NUMBER: 02-162-15R
DATE: 09/10/15
REVISED: 09/11/15

SUBJECT: Change to Engine Oil Pressure Switch

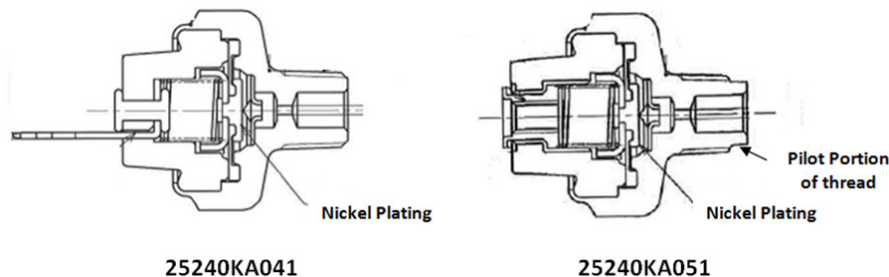
This Service Information bulletin announces a design change to the oil pressure switch assembly. Nickel plating has been applied to the internal switch contacts to enhance their durability and reduce the possibility of poor contact which could affect operation or cause improper illumination of the oil pressure warning lamp. A small pilot portion was added to the threaded area on p.n. 25240KA051 as shown in the illustration below.
